TAC: Special Occupancy

Total Mods for **Special Occupancy** in **Approved as Modified** : 24

Sub Code: Building

Fig. 1

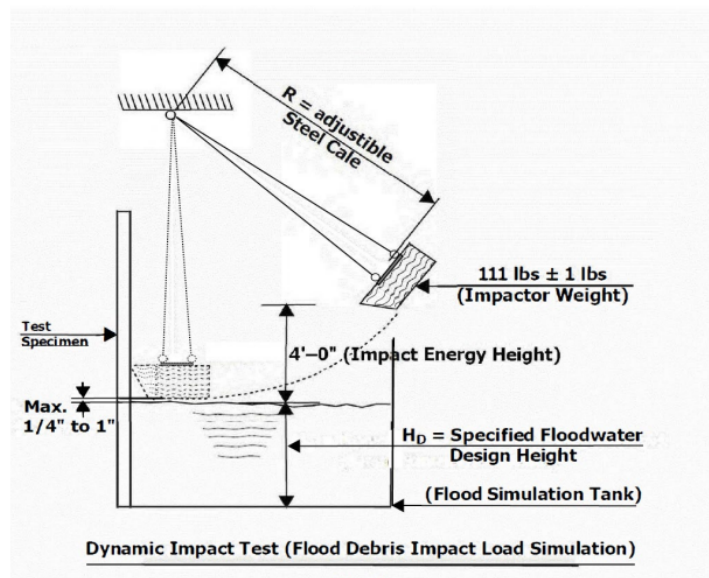
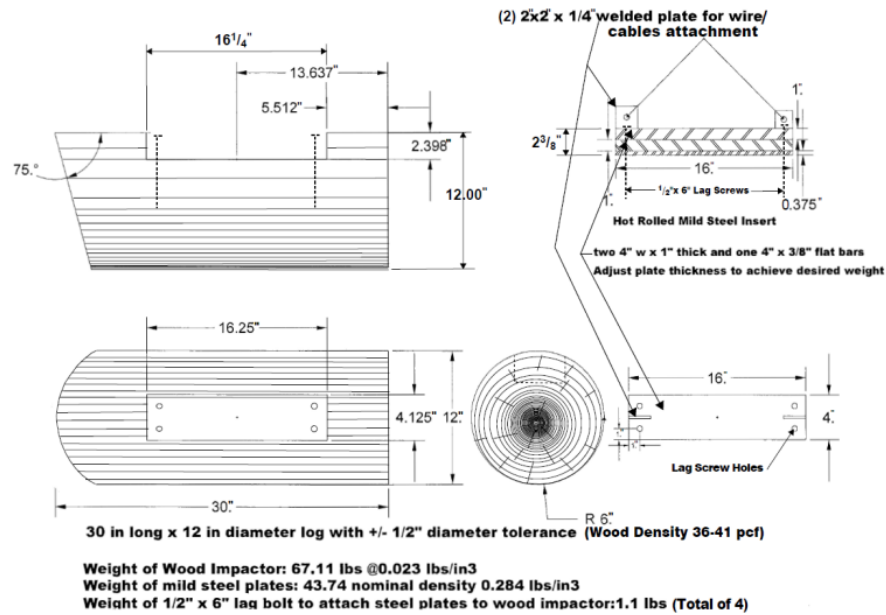
Southern Pine #2 wood log having a density of 36-41 lbs./ft³ at 19-20% moisture contents. The impactor must have a ~~25~~15-degree cut on the impact leading edge and be suspended from a carriage and support system using two 1/8-inch diameter steel cables or other suitable device as shown in Figure 1. The total weight of the impactor assembly must be...

6.2.2.2 The impactor for the debris impact load test fixture consists of a 12-inch+/- 1/2 inch diameter by 30 inch long Southern Pine #2 wood log having a density of 36-41 lbs./ft³ at 19-20% moisture contents. The impactor must have a ~~25~~15-degree cut on the impact leading edge and be suspended from a carriage and support system using two 1/8-inch diameter steel cables or other suitable device as shown in Figure 1. The total weight of the impactor assembly must be...
